**SUBDIVISION
PLANNED UNIT DEVELOPMENT &
REZONING
STAFF REPORT**

Date: June 5, 2014

Calaway-Jones East Subdivision

Subdivision approval to create 6 legal lots of record from a
portion of 2 existing lots; Planned Unit Development
Approval to allow reduced rear yard setbacks; and
Rezoning from R-1, Single-Family Residential, to B-2,
Neighborhood Business District, to allow a retail center.

SITE PLAN

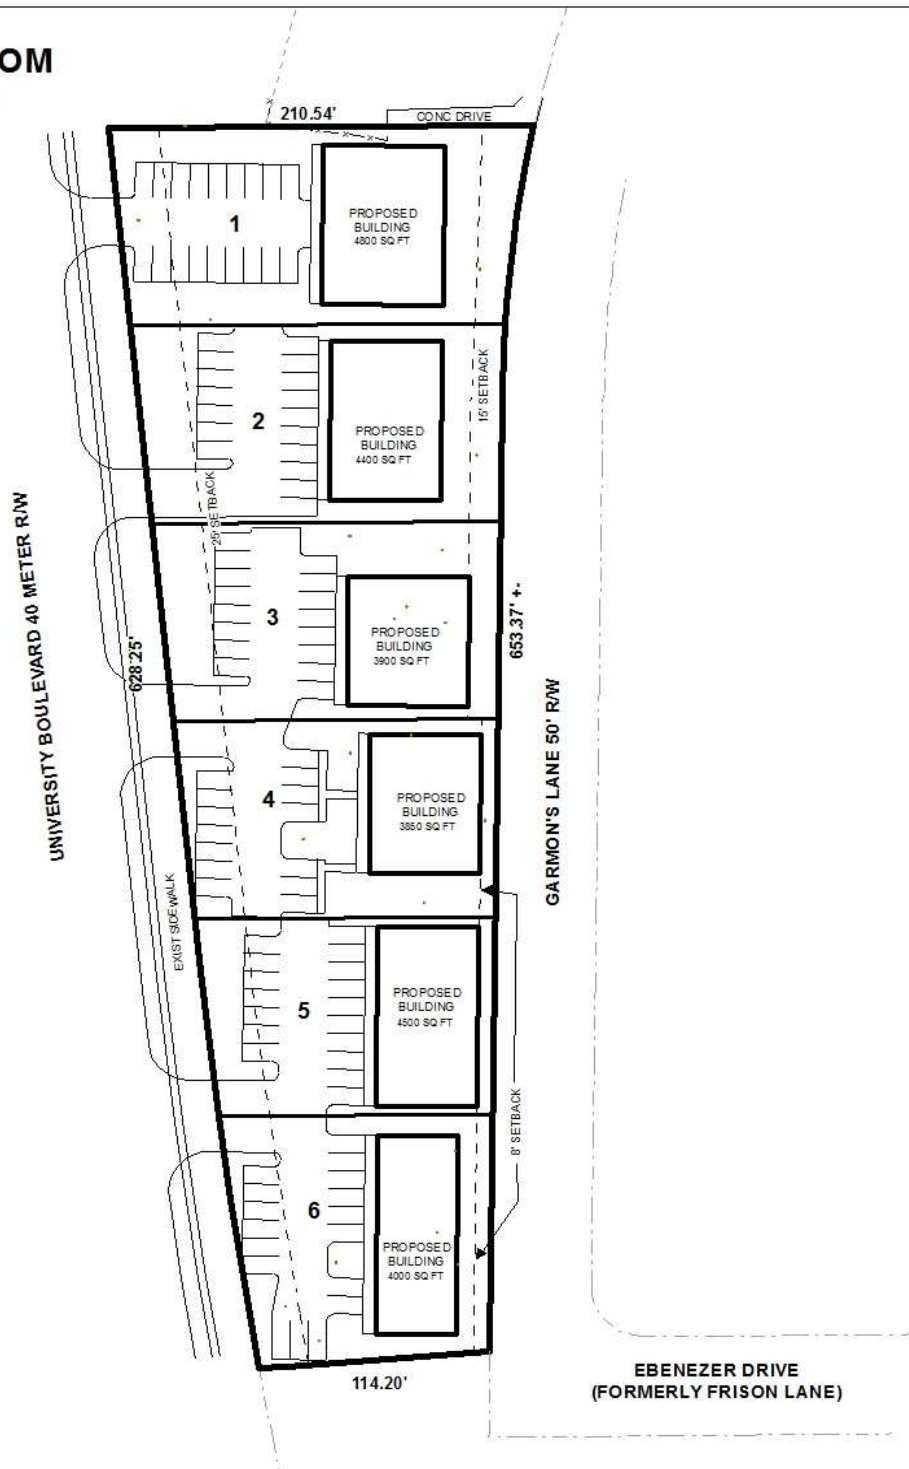
The 25' minimum building setback line is depicted along Demetropolis Road; however, along Garmons Lane, at the rear of the site, a 15' rear yard setback is depicted for the proposed Lots 1-

3 and an 8' rear street yard setback for the proposed Lots 4-6. Because the site is adjacent to residentially used property to the rear, across Garmons Lane, the proposed Lots 4-6 should illustrate a minimum 10' rear yard setback, to include a 10' Residential Buffer. If a privacy 6' fence is proposed as a Residential Buffer, it should be depicted 5' from the property line rear property line along Garmons Lane.

Further, a 10' setback and Residential Buffer should be required along the Northern lot line of the proposed Lot 1 and along the Southern lot line of the proposed Lot 6, where the site abuts residentially used property. A revised site plan should depict the required buffer compliance.

It should be noted that there appear to be several deficiencies on the site plan which impact the PUD aspect of the applications. The site plan does not indicate:

- 1) A 10' residential buffer in compliance with Section 64-4.D. of the Zoning Ordinance;
- 2) Tree and Landscaping in compliance with Section 64-4.E. of the Zoning Ordinance;
- 3) Dumpster(s) in compliance with Section 64-4.D.9. of the Zoning Ordinance or a note stating garbage collection will be via curb-side pick-up;
- 4) Proposed lighting in compliance with Sections 64-4.A.2., 64-6.A.3.c., and 64-6.A.8. of the Zoning Ordinance;
- 5) Any proposed signage information to include freestanding and monument sign structures;
- 6) A sidewalk along Garmons Lane or the provision of a Sidewalk Waiver request; and
- 7) Proposed onsite traffic circulation or accessible parking spaces, curbing or bumper stops.

The site plan provides a chart in reference to the proposed landscaping; however, the site plan should be revised to illustrate and quantify full compliance with the tree and landscaping

Although the site plan illustrates parking spaces for each proposed lot, Staff could only verify the proposed parking at a ratio of 1 space per 300 square feet (1:300) for retail/office uses. Any proposed restaurant or any other uses which would require a parking ratio of higher than 1:300 would require a revised site plan for staff to verify if parking is compliant.

It should be pointed out that no accessible spaces or accessible routes are depicted on the site plan. The building code (and Americans with Disabilities Act (ADA)) requires a certain percentage of parking spaces to be accessible parking spaces with one of every 6 accessible parking spaces being van accessible parking spaces according to the applicable building code section 1106 (and 2010 ADA Standards for Accessible Design). Although the Planning Section does not enforce accessible parking or ADA, certain aspects of ADA do impact site design, and as PUDs are site plan specific, a revised PUD site plan should depict design compliance with the requirements of the building code (ADA).

It is important to note that the proposed Lot 1 illustrates a portion of existing fencing and a portion of an existing driveway for the adjacent residential lot to the north, which appears to have been constructed across the lot line in error. The existing fencing and driveway which was constructed across the property line into this site should be removed by the property owner to the north and a revised site plan should depict these changes.

- 1) Revision of the site plan to illustrate a 10' residential buffer in compliance with Section 64-4.D. of the Zoning Ordinance where the site abuts residentially used property along the Northern lot line of Lot 1, along the rear lot lines of Lots 1-6, and along the Southern property line of Lot 6. Any 6' privacy fence proposed along Garmons Lane should be set back 5' from the property line;

- 2) Revision of the site plan to illustrate and quantify full compliance with the tree and landscaping requirements of Section 64-4.E. of the Zoning Ordinance;

- 3) Revision of the site plan to depict onsite traffic circulation and illustrate a compliant number of accessible parking spaces for all proposed lots and design compliance with the requirements of the applicable building code section 1106 (and 2010 ADA Standards for Accessible Design);

- 4) Depiction of any proposed lighting along with a note stating any new lighting on the site will have to comply with the requirements of Sections 64-4.A.2., 64-6.A.3.c., and 64-6.A.8. of the Zoning Ordinance. Photometric plans will be required at the time of permitting;

- 5) Depiction of any proposed dumpsters on the site plan in compliance with Section 64-4.D.9. of the Zoning Ordinance or placement of a note on the site plan stating that garbage collection will be via curbside pick-up;

- 6) Depiction of a sidewalk along Garmons Lane;
- 7) Compliance with Engineering comments: *(1. Due to the proposed subdivision lots having frontage on both University Blvd. and Garmons Lane the street addresses will need to be discussed with the Engineering Department (208-6216) prior to submitting any permits. ADD THE FOLLOWING NOTES TO THE PUD SITE PLAN: 2. Any work performed in the existing ROW (right-of-way) such as driveways, sidewalks, utility connections, grading, drainage, irrigation, or landscaping will require a ROW permit from the City of Mobile Engineering Department (208-6070) and must comply with the City of Mobile Right-of-Way Construction and Administration Ordinance (Mobile City Code, Chapter 57, Article VIII). 3. A Land Disturbance Permit application shall be submitted for any proposed land disturbing activity with the property. A complete set of construction plans including, but not limited to, drainage, utilities, grading, storm water detention systems, paving, and all above ground structures, will need to be included with the Land Disturbance permit. This Permit must be submitted, approved, and issued prior to beginning any of the construction work. 4. Any and all proposed land disturbing activity within the property will need to be submitted for review and be in conformance with the Storm Water Management and Flood Control Ordinance (Mobile City Code, Chapter 17, Ordinance #65-007 & #65-045); the City of Mobile, Alabama Flood Plain Management Plan (1984); and, the Rules For Erosion and Sedimentation Control and Storm Water Runoff Control. 5. The proposed development must comply with all Engineering Department Policy Letters.);*
